ENC10-1 Tank Dimensions

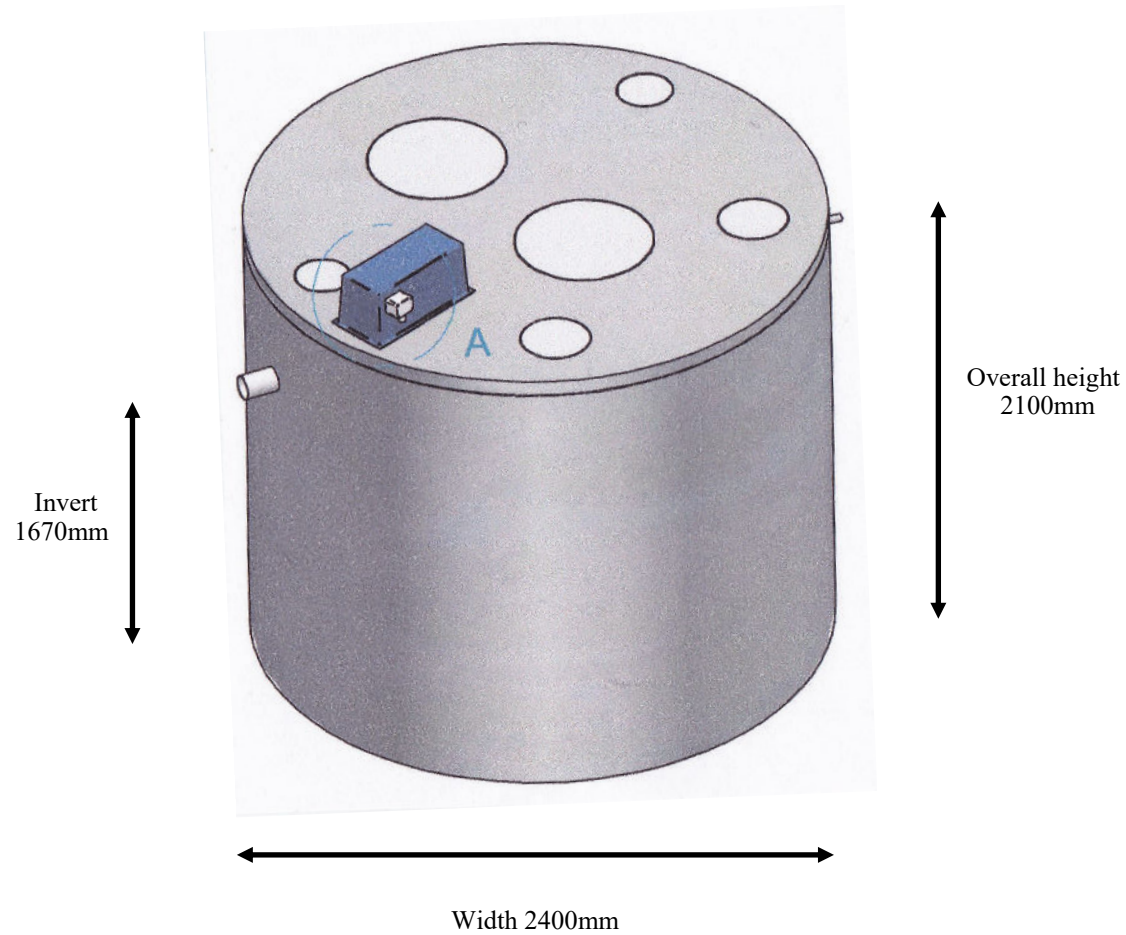
HOLE WIDTH SOULD BE NO LESS THAN 3000mm TO REMOVE LIFTING LUGS
